Re: On-Going Services
Heritage Park Section 3 Subdivision Final Plat and Construction Plans – 1st Submittal Review
Angleton, Texas
HDR Job No. 10336228

HDR Engineering, Inc. (HDR) has reviewed the plat for the above referenced subdivision and offers the following comments:

PLAN & PROFILE
ELM STREET

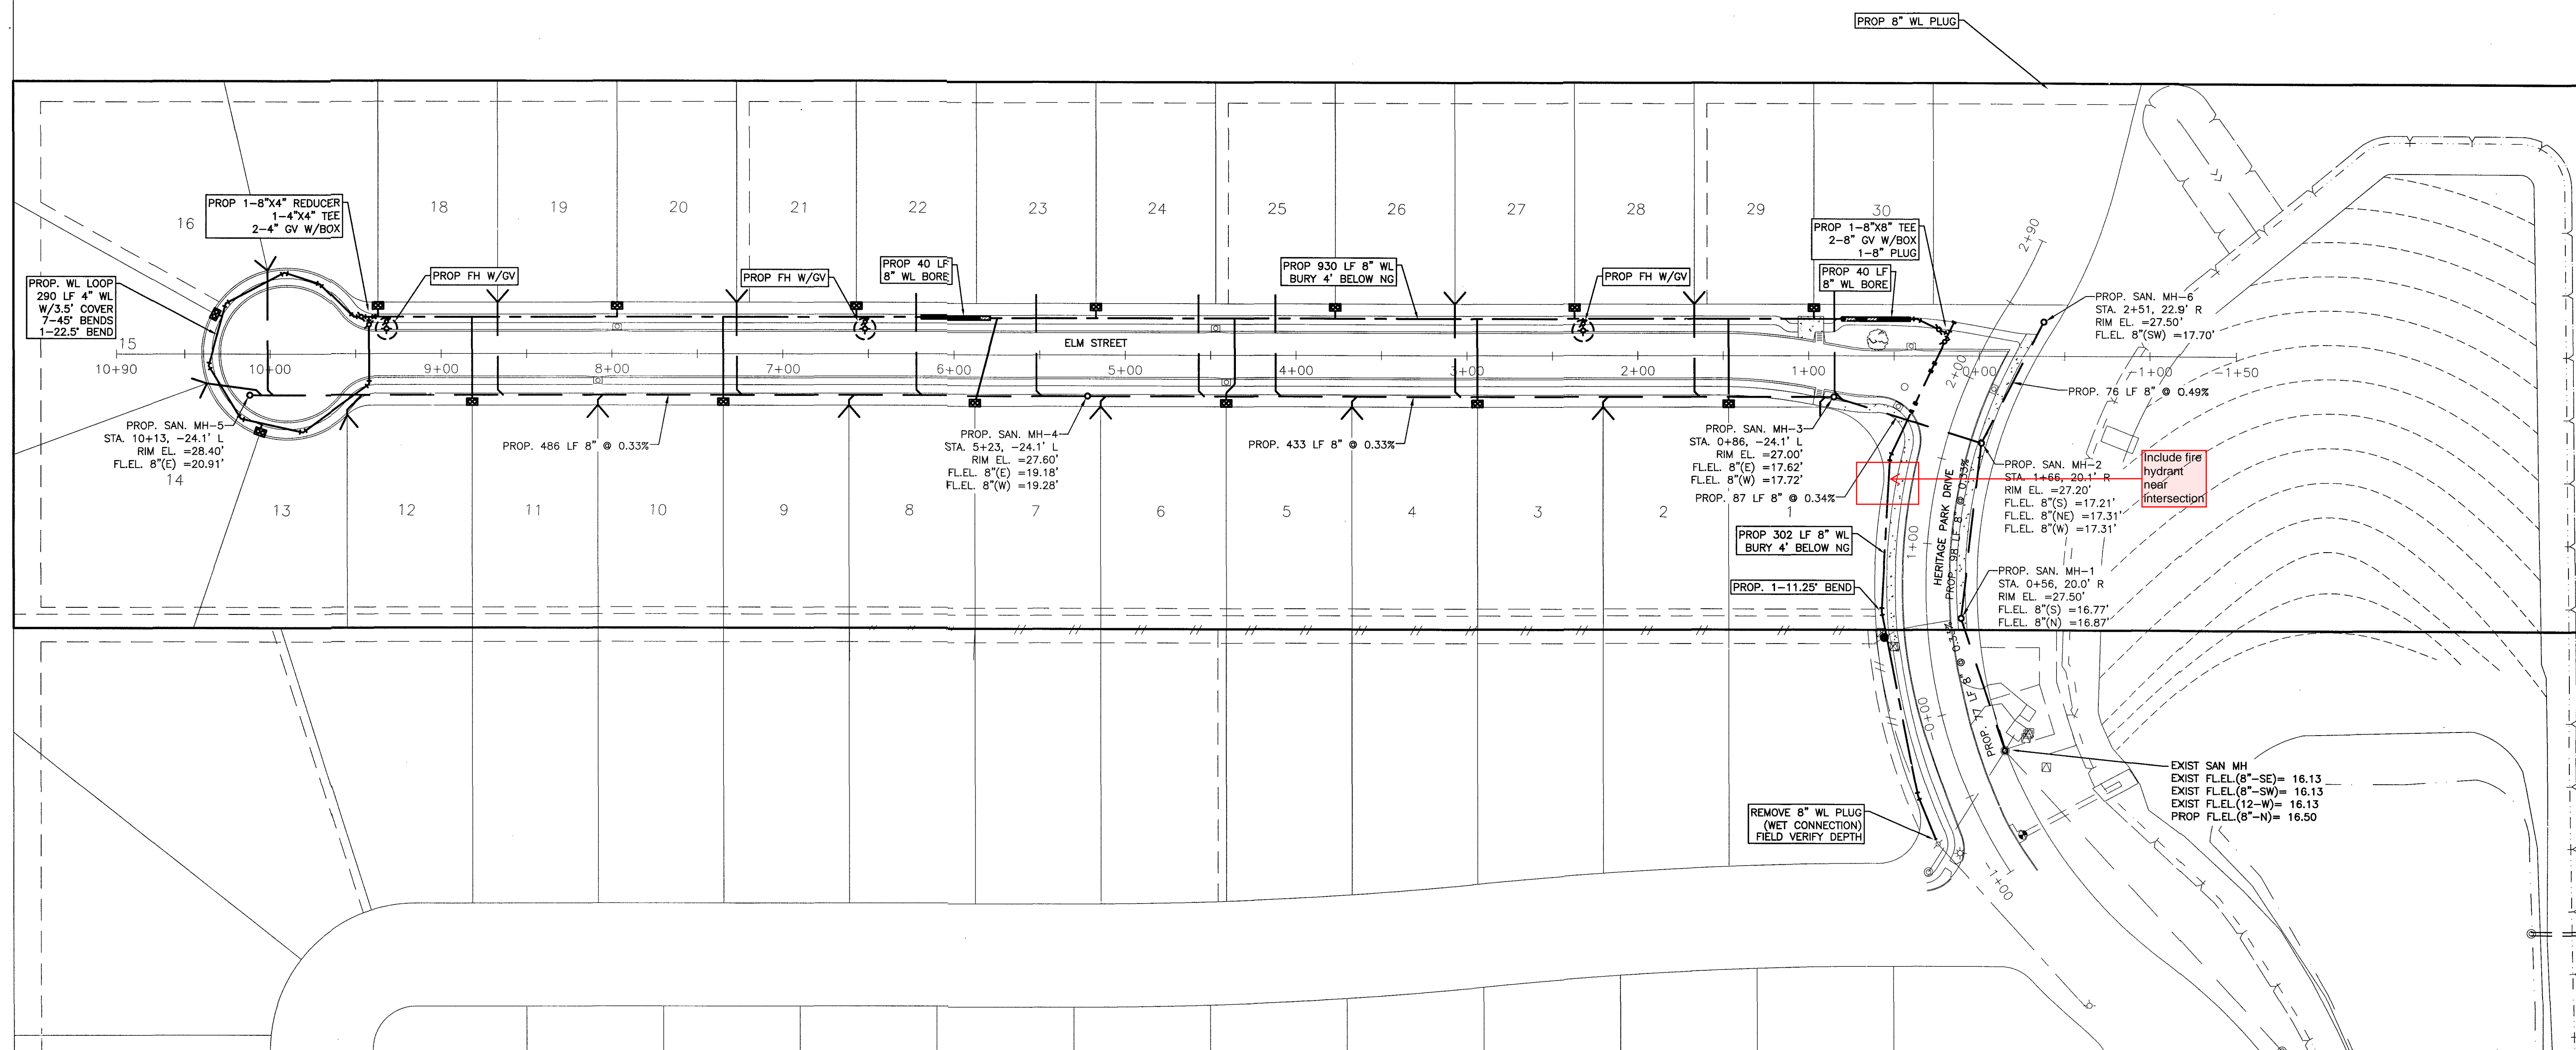
1. Provide 4-ft minimum cover for proposed water line.

UTILITY LAYOUT
PROJECT NO. 15012
7

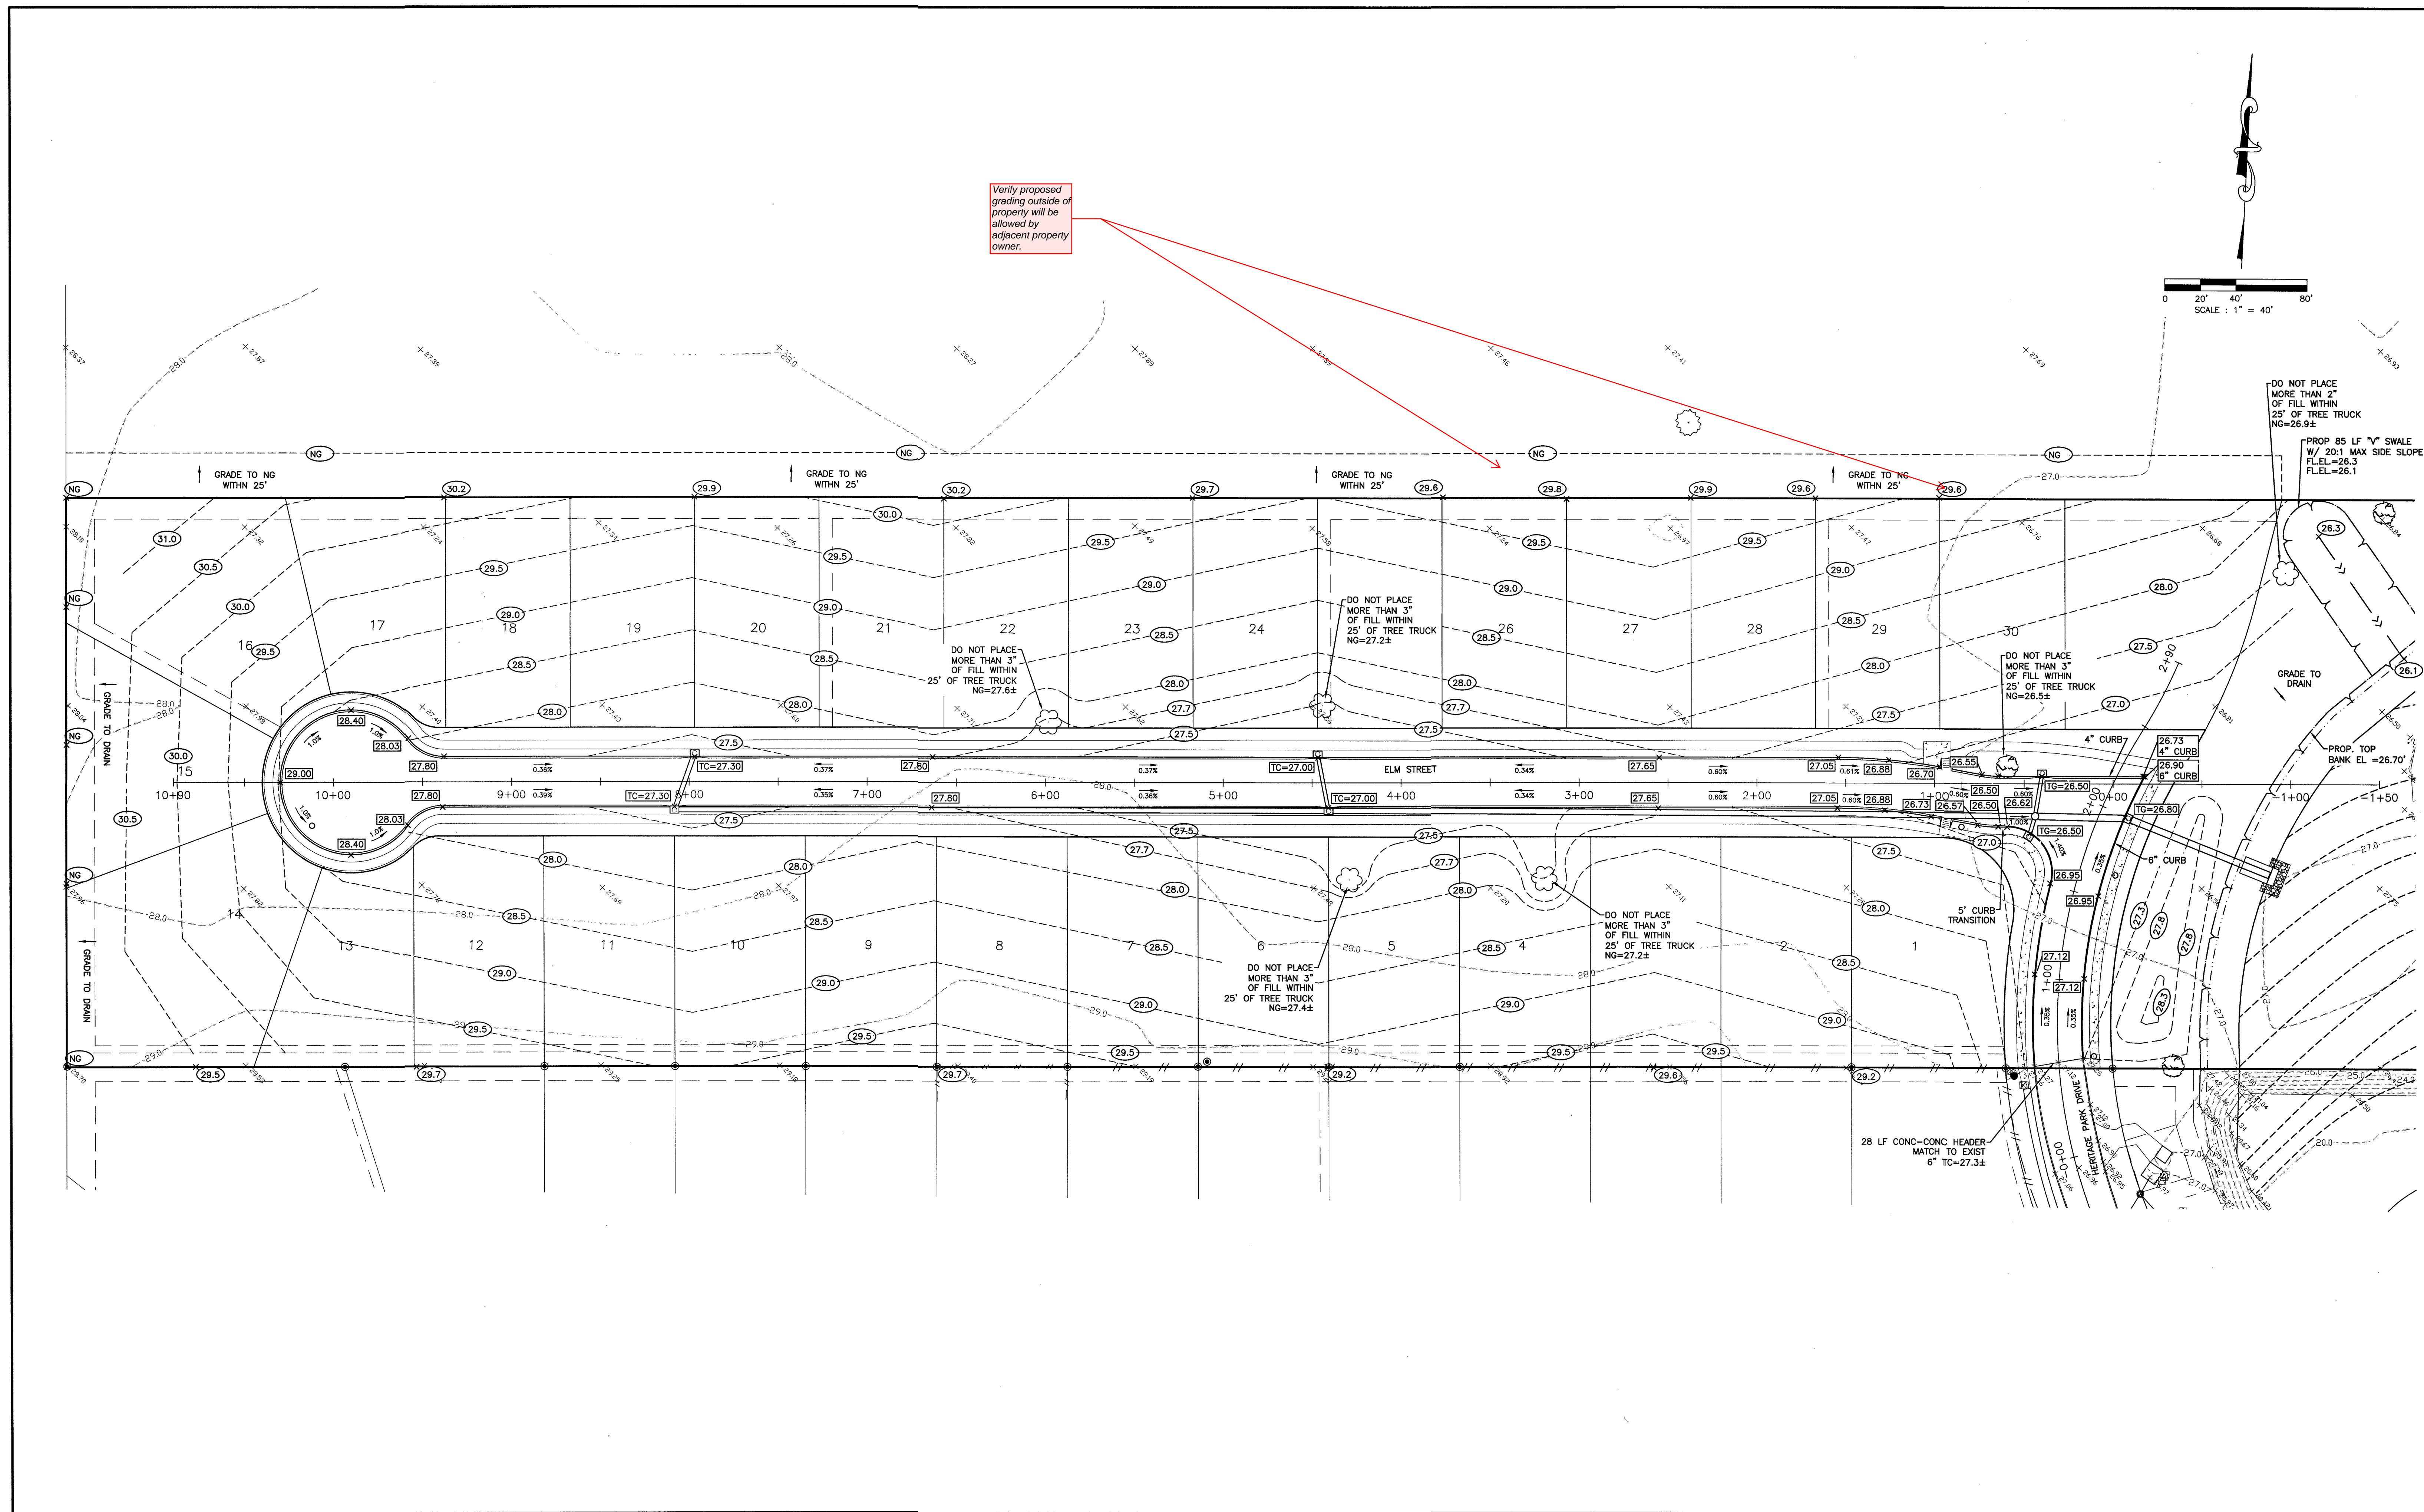
1. Include fire hydrant near intersection where shown on the review drawings.

LOT GRADING PLAN

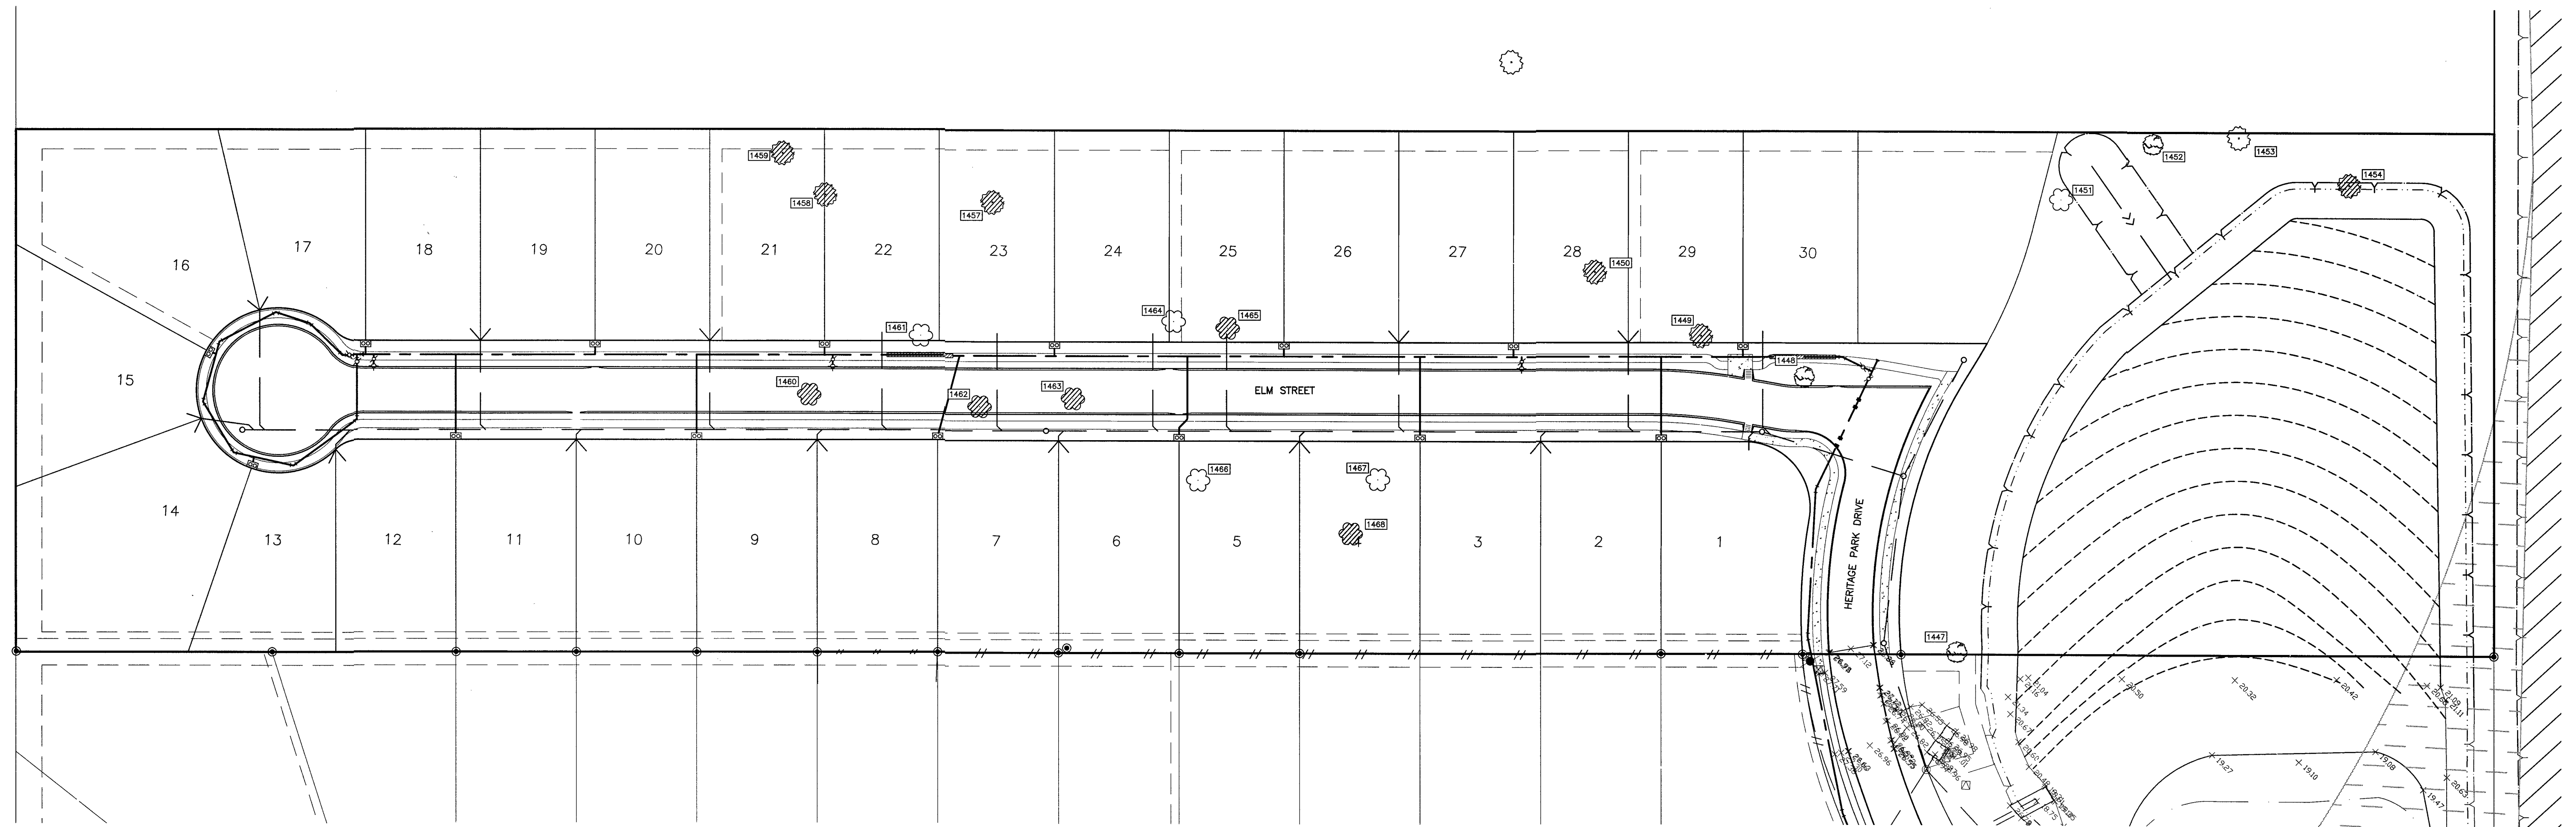
1. Verify proposed grading outside of property will be allowed by adjacent property owner.

TYPICAL SINGLE ROADWAY SECTION FOR
CONCRETE PAVEMENT WITH 4"x12" CURB

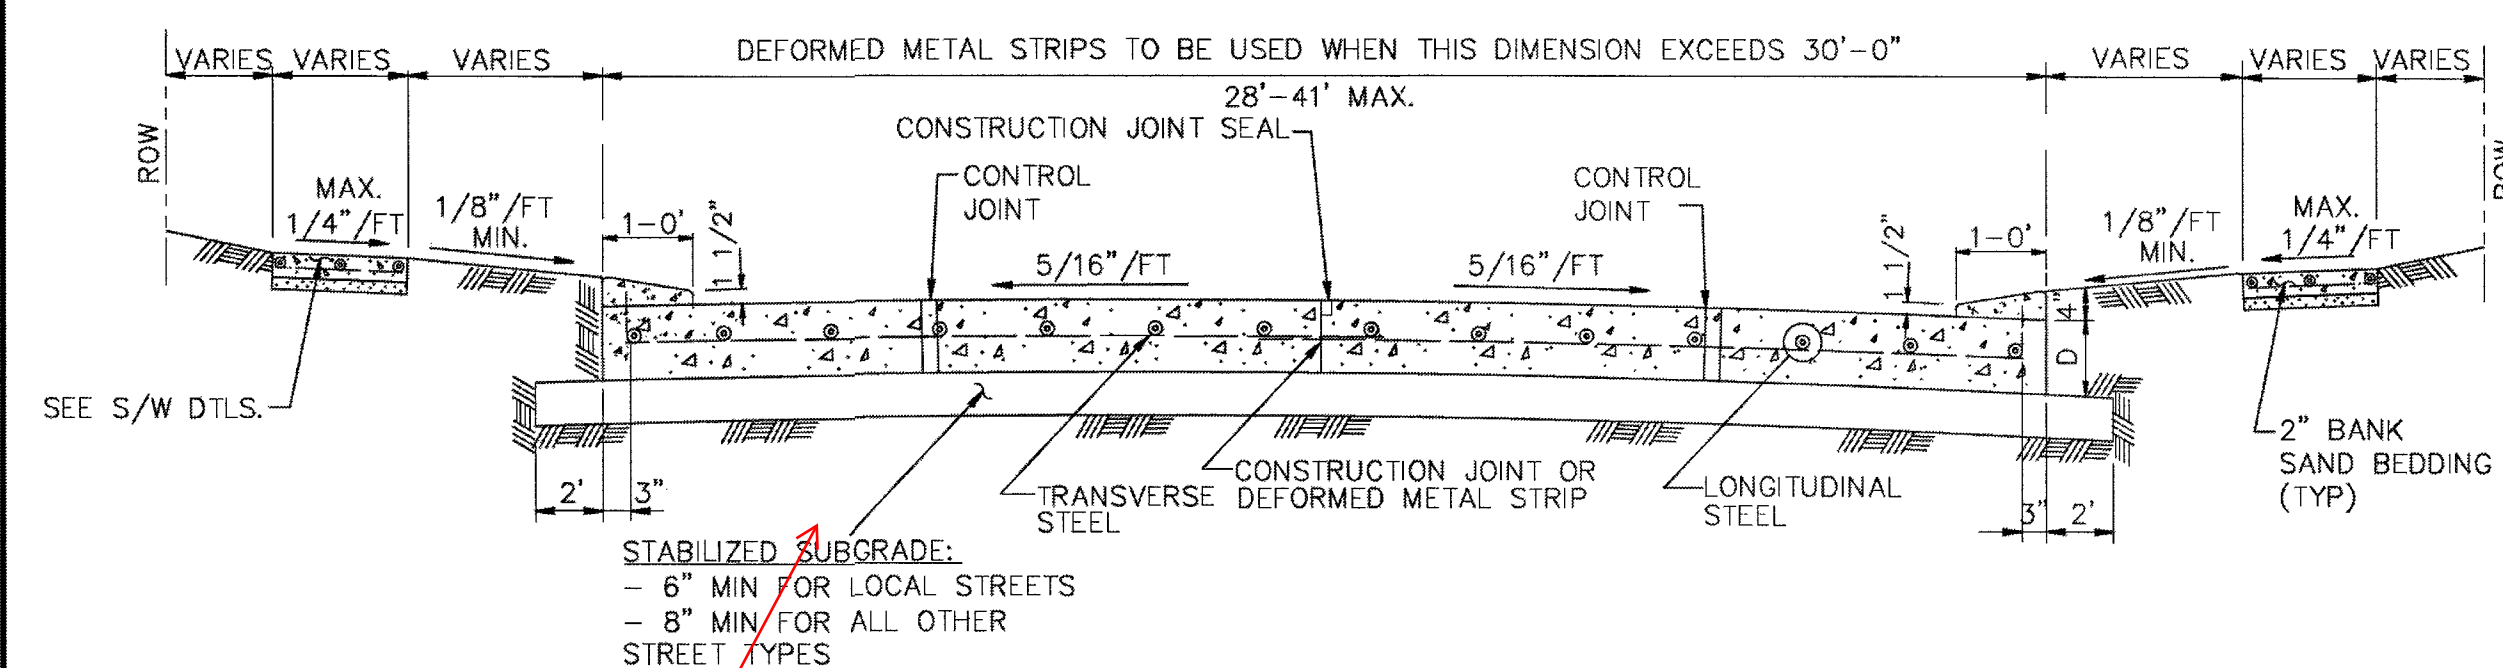
1. For “SL-ST-19 Typical Single Roadway Section For Concrete Pavement With 4”x12” Curb”, Geotechnical recommendations and report reference to be noted with this detail to verify minimum standards are met.

Geotechnical recommendations and report reference to be noted with this detail to verify minimum standards are met
